Access Compliance Report

Public Rights-of-Way

(Curb Ramps)

Intersection ID: 3026	Main Street: FOX_HILL_DR	Cross Street: FOX_TROT_DR	Location:	N
ADA ID: 4FE675C7A3C1	Ramp Type: Perp	Initial Pass/Fail: Fail	Overall Compliance: No	Severity Score: 1.25
Codes/Mitigation Info/Possible Solution		Field Measurements/Component Compliance

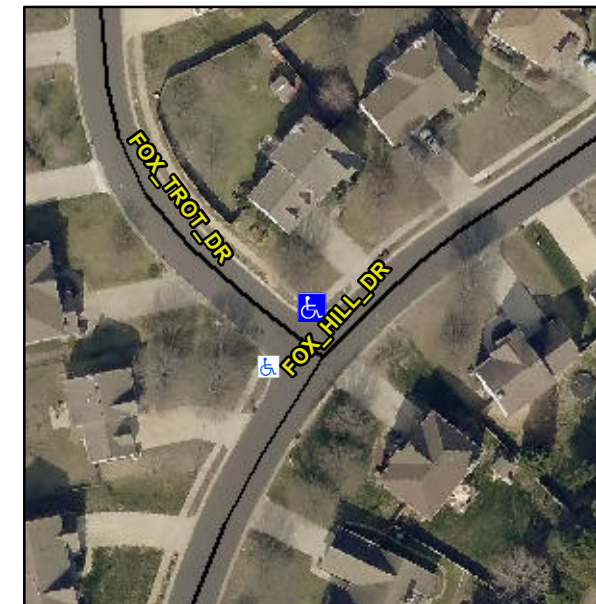
Not Found, R304.5.3

Compliance	Description	Data	Compliance	Description	Data
N/A	Ramp Length (in)	64.0	Yes	Ramp Slope (%)	5.0
Yes	Ramp Width (in)	48.0	No	Ramp XSlope (%)	2.2
N/A	Flare Type LT	N/A	N/A	Flare Type RT	N/A
N/A	Flare Slope LT (%)	N/A	N/A	Flare Slope RT (%)	N/A
N/A	Flare Traversable LT?	N/A	N/A	Flare Traversable RT?	N/A
N/A	Landing Length (in)	N/A	N/A	DWS Provided?	N/A
N/A	Landing Width (in)	N/A	N/A	DWS Contrast?	N/A
N/A	Landing Slope (%)	N/A	N/A	DWS Length (in)	N/A
N/A	Landing X Slope (%)	N/A	N/A	DWS Full Width?	N/A
N/A	Landing Curb? (Y/N)	N/A	N/A	DWS Offset (in)	N/A
N/A	Shared Landing?	N/A			
N/A	Gutter Ponding?	N/A	N/A	Gutter Slope (%)	N/A
N/A	Gutter Lip Ht (in)	N/A	N/A	Gutter X Slope (%)	N/A
N/A	Painted X Walk1?	No	N/A	Painted X Walk2?	N/A
	X Walk 1 Direction	To SW		X Walk 2 Direction	N/A
N/A	X Walk 1 Width (in)	N/A	N/A	X Walk 2 Width (in)	N/A
	X Walk 1 Slope (%)	1.6		X Walk 2 Slope (%)	N/A
	X Walk 1 X Slope (%)	1.4		X Walk 2 X Slope (%)	N/A

Remove & Replace Entire Ramp.
